RENESAS TECHNICAL UPDATE

Product Category	MPU/MCU		Document No.	TN-SH7-A760A/E	Rev.	1.00
Title	Correction of SH7785 PCI Controller Hardware Manual		Information Category	Technical Notification		
Applicable Product	SH7785 Group	Lot No.	Reference Document	SH7785 Hardware Manual (REJ09B0261)		
		All lots

The SH7785 PCI Controller Hardware Manual has following errata.

Figure 13.27 Master Write Cycle in Host Mode (Burst, with Stepping)

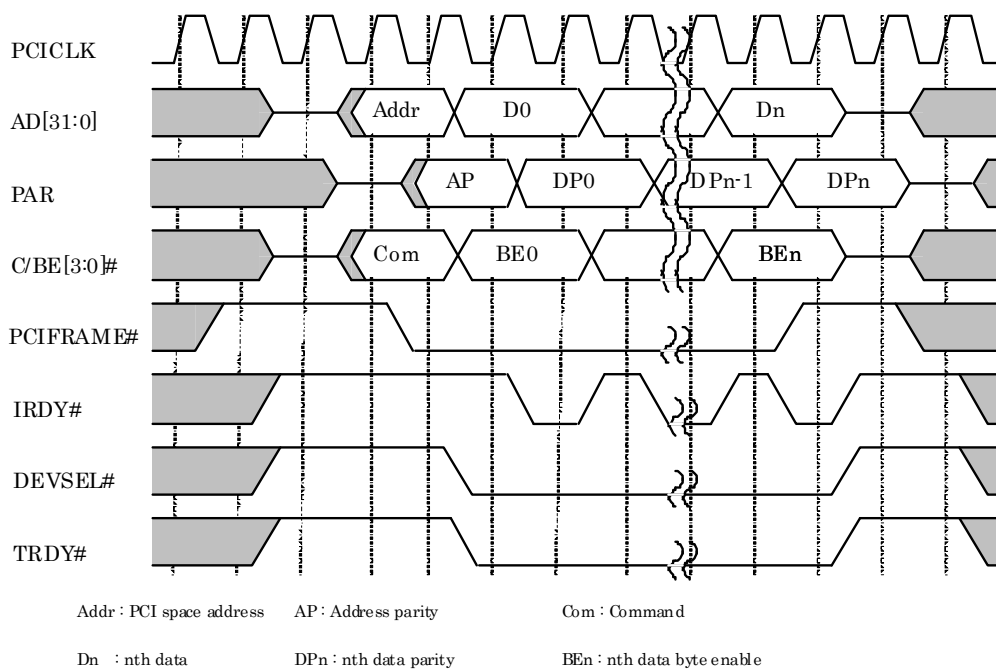
And, there are some wrong timing charts in Figure 13.27 and Figure 13.28.

And, Figure 13.27 Master Write Cycle in Host Mode (Burst, with Stepping) and Figure 13.28 Target Memory Read Cycle in Host Bus Bridge Mode (Burst, with Stepping) are corrected as followings.
